PRODUCT ADVISORY

PA688

SUBJECT: Freightliner Chassis with Tri-Axle Rear Air Suspension

**Subject: Hendrickson Primaax EX 69,000 lb
Tri-Axle Rear Air Suspension Height-Control
Valve Relocation**

Figure 3. Bottom end of ride height control linkage

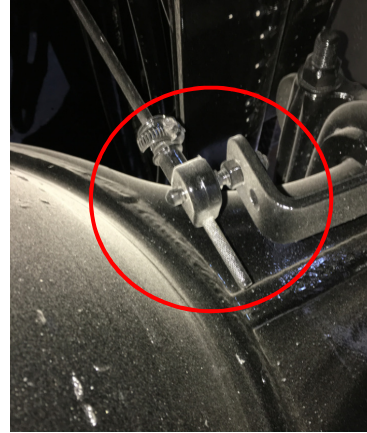
Terex aerial devices and digger derricks, produced from January 2015 to June 2020, installed on Freightliner chassis with Hendrickson Primaxx tri-axle rear air suspension may have the ride height control linkage contact the bottom of the subframe. Repeated contact of the ride height control linkage with the subframe may cause the linkage to fail. Failure of the linkage may affect the rideability of the chassis as the chassis will not be able to self-level.

Inspect the ride control linkage, including the attachment points as shown in Figures 1, 2 & 3, for signs of damage such as bending and/or cracking or indications of contact with the bottom of the subframe. Complete this inspection at the next scheduled inspection interval or at the next scheduled servicing of the chassis. If the linkage has failed, limit road travel to reduce the amount of shock loading into the aerial device or digger derrick until repaired.

If the ride control linkage contacts the bottom of the subframe or shows any damage, contact your nearest Freightliner dealership to determine the required repairs and reference Freightliner Customer Advisory Letter CAL FTL 32-006. If you are unable to locate your dealership, go to the Freightliner website, freightliner.com, and click the DEALERS button in the upper right-hand corner to search for the local dealership.

Fig. 1, Location of Height-Control Valves

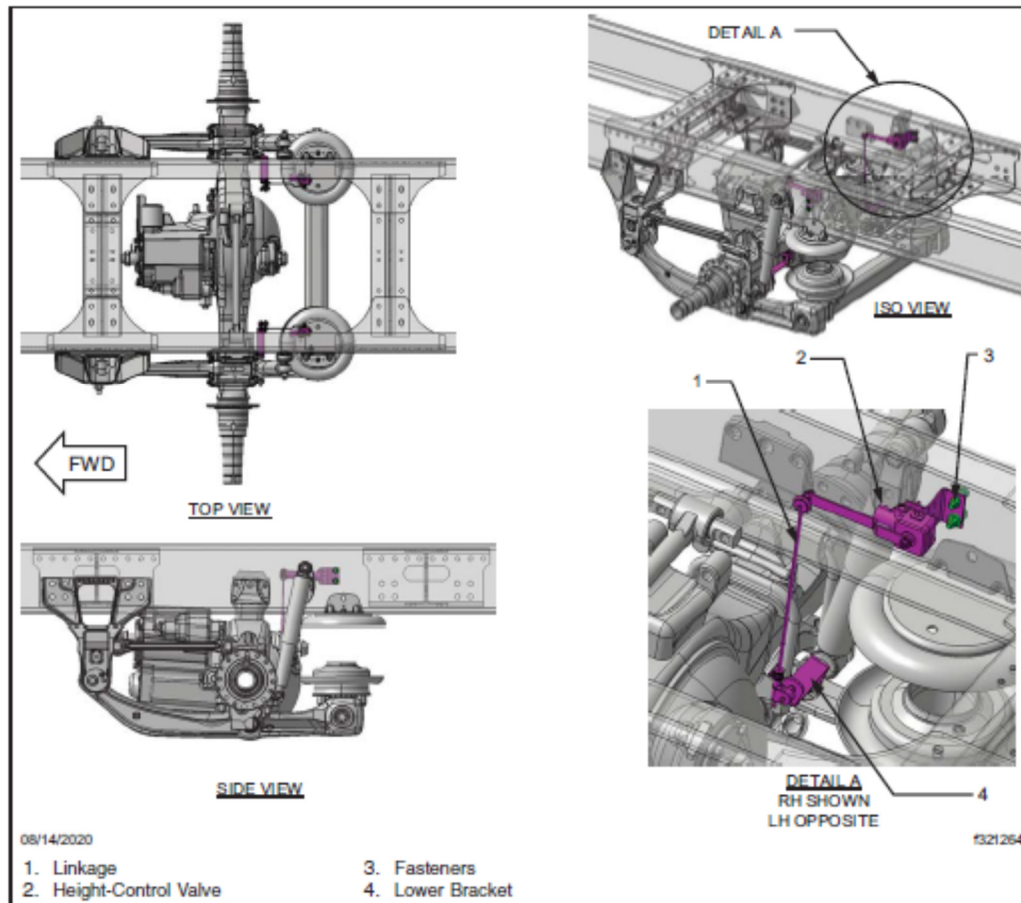
The attached document provides work instructions for relocating the height-control valve downward 1.62 inches (41.3 mm) to prevent the linkage from protruding above the top flange of the frame when the suspension air is dumped.

1. Park the vehicle on a level surface, set the parking brakes, and *chock the tires*.
2. Put the transmission in neutral and build the air pressure to at least 100 psi. Shut down the engine.
3. Release the parking brakes.
4. Locate the height-control valves installed just rear of the mid-axle inside the left-hand and right-hand frame. See [Fig. 1](#).

Fig. 2, Measuring For the New Frame Rail Holes

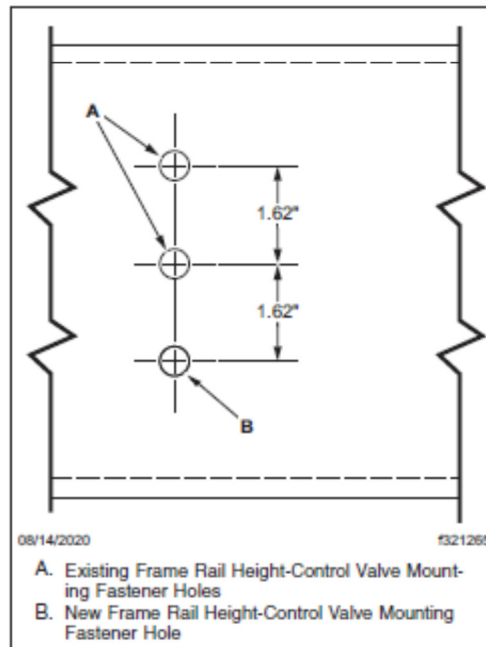
5. Disconnect the linkage from the lower bracket on both sides of the vehicle.
6. Pin both height-control valve levers in the neutral position with a 5/32-inch drill bit.
7. Remove the height-control valve mounting fasteners from the frame and move the valves and linkages away from the frame.
8. Mark both the left-hand and right-hand frame rail 1.62 inches (41.3 mm) below the lower existing height-control valve drilling on each rail. See [Fig. 2](#).

IMPORTANT: Drilling must be done at low-speed with a high-speed steel drill bit.

9. Drill a 1/4" diameter pilot hole at both the left-hand and right-hand frame rail marks.
10. Finish the mounting holes with a 7/16" diameter drill bit at low speed.
11. Install the height-control valves on the lower two holes using the existing 3/8" fasteners.
12. Install the linkage to the lower bracket by adjusting the rod in the lower rubber adjustment sleeve.
13. Remove the drill bit pins from the height-control valve levers.
14. Check the suspension ride height by measuring between the shock mounting bolts. Measure from the centerline of the upper shock bolt to centerline of the lower shock bolt. The distance should equal 20.07 inches (50.98 cm). If necessary, set the suspension height by adjusting the rod in the lower rubber adjustment sleeve to achieve 20.07 inches (50.98 cm). See [Fig. 3](#).
